Your Comment on the Ōhoka Residential Subdivision

This submission strongly opposes the proposed Ōhoka Residential Subdivision (FTAA-2606-1253). Drawing on my professional expertise as a mathematician and my lived experience as a directly affected downstream resident, a critical review of the application reveals fundamental engineering flaws, severe data omissions, and a complete lack of regional economic justification.

Figure 1: For the 50-year ARI, the green path represents the applicant's modelled pre-development flow. The red path indicates the actual overland flow observed in reality, which reaches over 200 mm deep in multiple places.

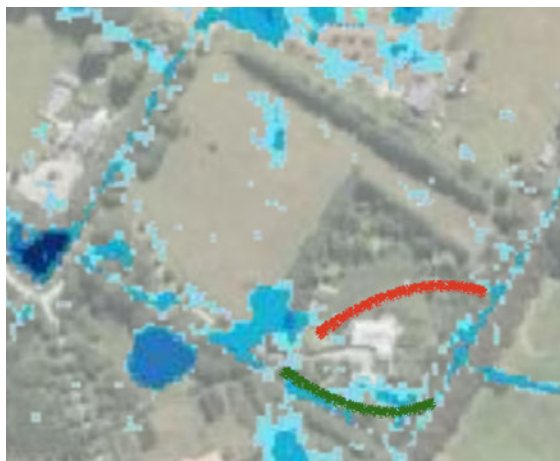
2.6 The applicant explicitly concedes that their flood modelling uses coarse data and is only valid at a broad catchment level, not at an individual property scale. Therefore, their definitive claim that there are "no adverse flooding effects" on downstream dwellings is entirely unsubstantiated. My ground-truthed experience exposes this flaw: the applicant's modelled baseline for a 50-year ARI event completely misrepresents the actual overland flow path on my property (Figure 1). The model predicts flow in the green area, whereas reality dictates flow along the red path, often exceeding 200 mm in depth during storms we have experienced several times in the last decade.

Figure 2: For the 200-year ARI, the indicated flow starts to match what happens in 50-year ARI events.

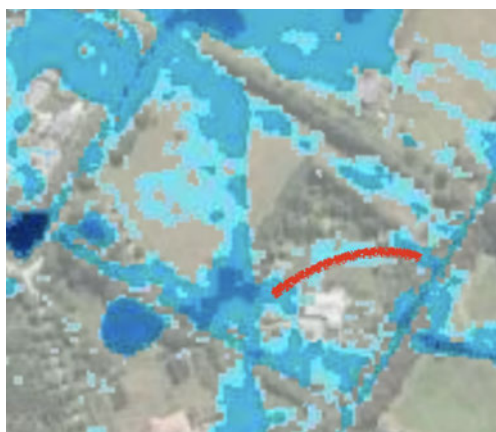
2.7 Tellingly, the applicant's model only begins to resemble the flooding we routinely experience when it runs a 200-year ARI scenario (Figure 2). Even then, it underestimates the true depth and spread of the water, which frequently washes over paths and against the northern foundations of my house. Because we have not experienced a true 200-year ARI rainfall event in the last decade, the fact that their 200-year model is required to replicate our modern 50-year reality proves the model is fundamentally inaccurate. If the baseline model cannot accurately replicate current, real-world flooding on immediate downstream properties, its post-development predictions are entirely unreliable and cannot be used to rule out severe adverse effects.
